## Arboricultural Impact Assessment

- **Development at 1686 Channel Highway, Margate and potential impact on the existing oak tree.**

4/03/2026

Figure 2. The Site Plan by Templo marked with the NRZ (green shading) and SRZ (red dashed circle) of the oak tree. Suggested TPZ in shown in yellow.

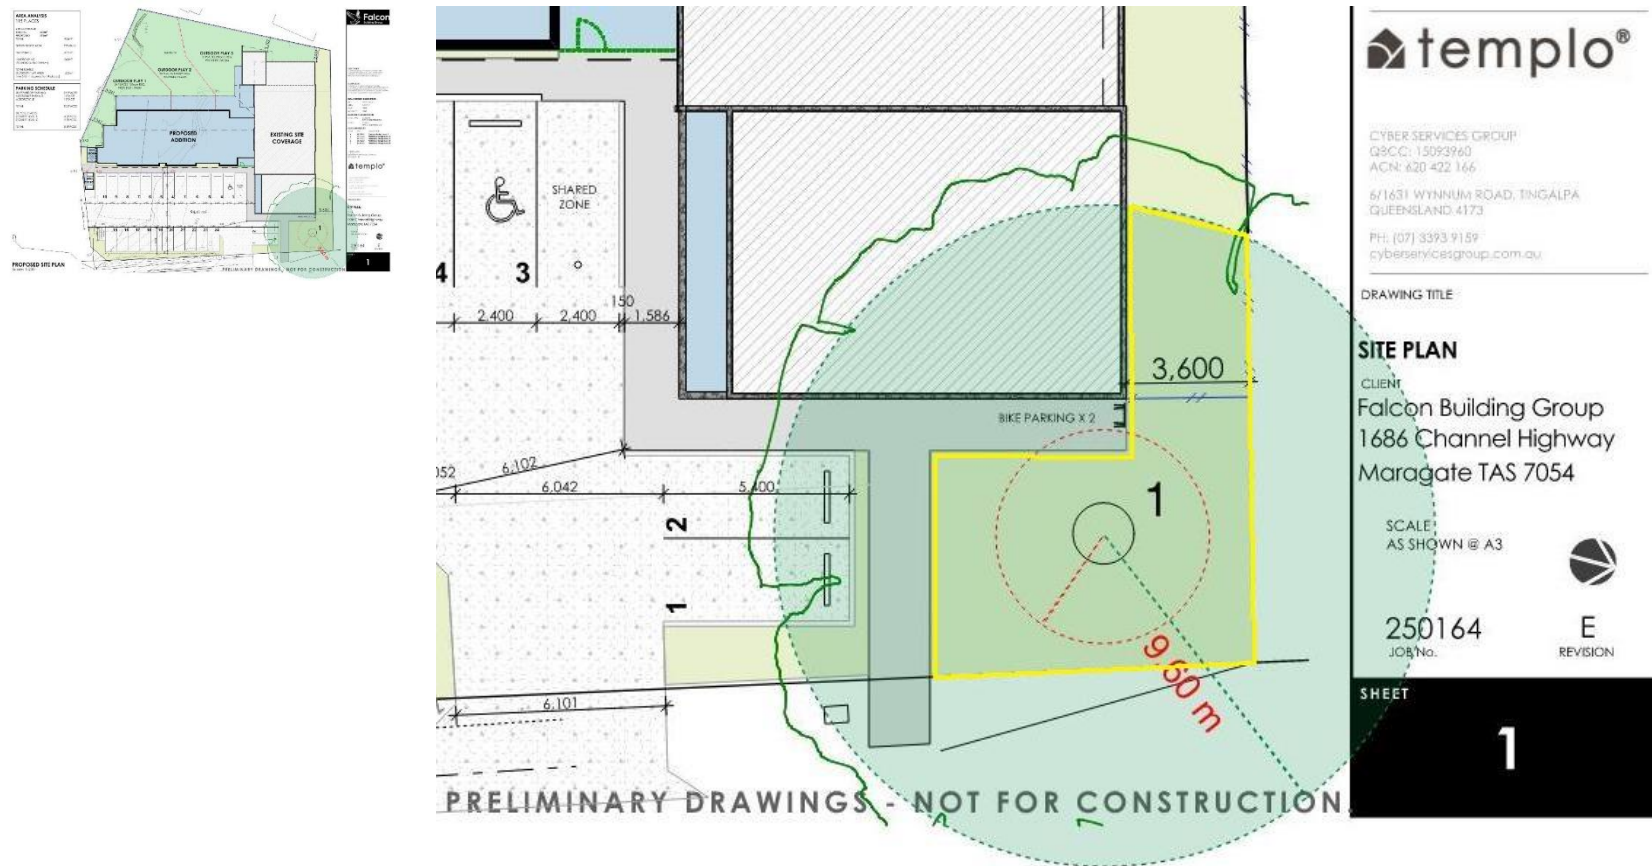
The proposed car parking and footpath construction near the mature pin oak cumulatively present a moderate encroachment over the tree’s NRZ that has already been substantially affected by historic road and property development.

The following are design suggestions that would substantially reduce the impact of the works despite a moderate level of encroachment by the footprint of the proposed additions.

- Consider construction of a laid paver path edged with wide steel flat bar pinned to the substrate between the Channel Highway and the existing building rather than a concrete path. Adoption of this construction method would require minimal excavation – essentially removal of the existing turf cover – and provide for infiltration of air and water into the existing root zone of the oak (Figure 4).
- Consider suspended slab construction for the extension of the footpath along the eastern side of the existing building rather than a retaining wall and a traditional concrete path. The proposed path footprint encroaches on the tree’s structural root zone and adoption of this construction method and pier footings would minimise potentially significant impacts on large roots of the oak tree (Figure 4 and 5).

- Adoption of the suggested construction methodology for the paths within the tree's NRZ is strongly encouraged (see Section 4.1).
- A modified TPZ is suggested, clear of the proposed additions' footprint. Establishment of a hard barrier may be impractical given the confines of the site, however the TPZ should be marked as a minimum with stakes and barrier tape.
